Mask Set Errata 2
MC9S12D64* Microcontroller Unit
(*Devices covered: MC9S12D64 and MC9S12DJ64)

This errata provides information applicable to the following MCU mask set devices:

- 1L86D

SPTEF FLAG SET WRONGLY**MUCTS00708**

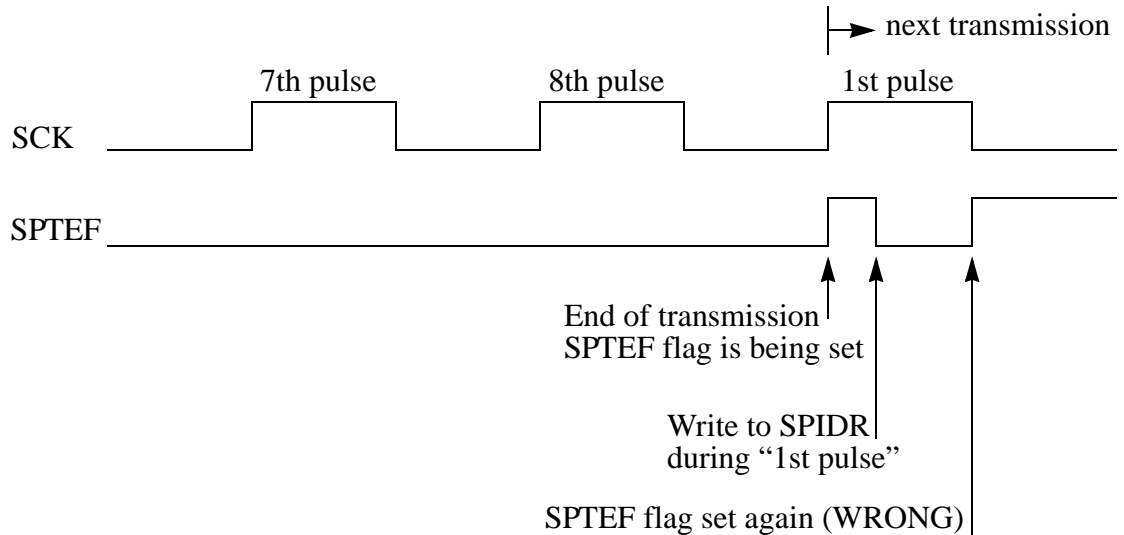
When the SPI is enabled in master mode, with the CPHA bit set, back to back transmissions are possible.

When a transmission completes and a further byte is available in the SPI Data Register, the second transmission begins directly after the “minimum trailing time”.

The problem occurs when, after the SPTEF flag has been set, a further byte is written into the SPI Data Register during the “1st pulse” of a subsequent transmission.

Then the SPTEF flag is set at the falling SCK edge of the “1st pulse” and data is transferred from the SPI Data Register to the transmit shift register. The result is that the transmission is corrupted and data is lost.

After the SPTEF flag has been set, a delay of 1/2 SCK period has to be added before storing data into the SPI Data Register.
